**Subject:** Review of Water Right Application LL-1903

# **Groundwater Application Review Summary Form**

Application # LL- <u>1903</u>
GW Reviewer M. Thoma Date Review Completed: <u>11/16/2021</u>
Summary of GW Availability and Injury Review:
☐ Groundwater for the proposed use is either over appropriated, will not likely be available in the amounts requested without injury to prior water rights, OR will not likely be available within the capacity of the groundwater resource per Section B of the attached review form.
Summary of Potential for Substantial Interference Review:
$\square$ There is the potential for substantial interference per Section C of the attached review form.
Summary of Well Construction Assessment:
☐ The well does not appear to meet current well construction standards per Section D of the attached review form. Route through Well Construction and Compliance Section.
This is only a summary. Documentation is attached and should be read thoroughly to understand the

#### Water-Level Measurements in Nearby Wells

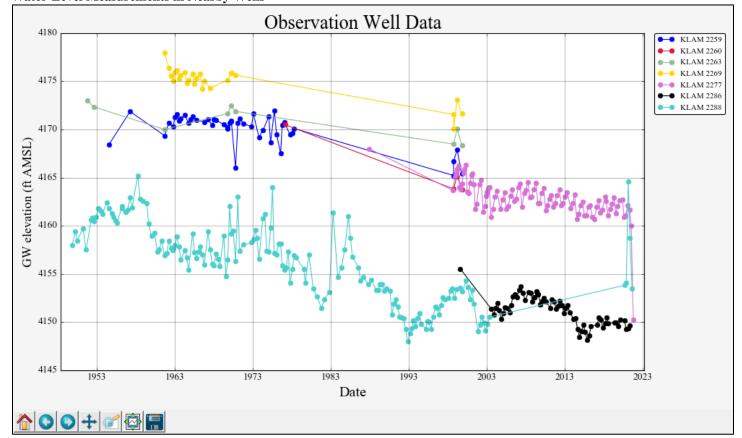
d.	☐ <b>Well reconstruction</b> is necessary to accomplish one or more of the above conditions. The problems that are likely to occur with this use and without reconstructing are cited below. Without reconstruction, I recommend withholding issuance of the permit until evidence of well reconstruction is filed with the Department and approved by the Groundwater Section.										
		<b>Describe injury</b> —as related to water availability— that is likely to occur without well reconstruction (interference w/senior water rights, not within the capacity of the resource, etc):										
B3.		bundwater availability remarks: A comparison of groundwater recharge to groundwater allocation has not been										
		formed for the Swan Lake valley and so groundwater over-appropriation cannot be determined. Water level data available										
		the area of the proposed POD show short-term (decadal) variability suggesting a strong relationship to climate cycles but overall decline in groundwater levels of approximately 10 ft over the period of record, which may be wholly due to

g-term climate trends. Therefore, there is not a preponderance of evidence that the proposed use would not be within the										
		acity of the resource and so conditions in B1(d) are recommended.

c.	$\square$ will not $or$ $\square$ will likely to be available within the capacity of the groundwater resource; or										
	d.	will, if properly conditioned, avoid injury to existing groundwater rights or to the groundwater resource:  i.   The permit should contain condition #(s) 7C (7-yr SWL); 7J (Scenic Waterway); 7T (Measuring Tube)										
		Medium Water-Use Reporting										
		ii. The permit should be conditioned as indicated in item 2 below.										
		iii.   The permit should contain special condition(s) as indicated in item 3 below;										
B2.	a.	☐ Condition to allow groundwater production from no deeper than ft. below land surface;
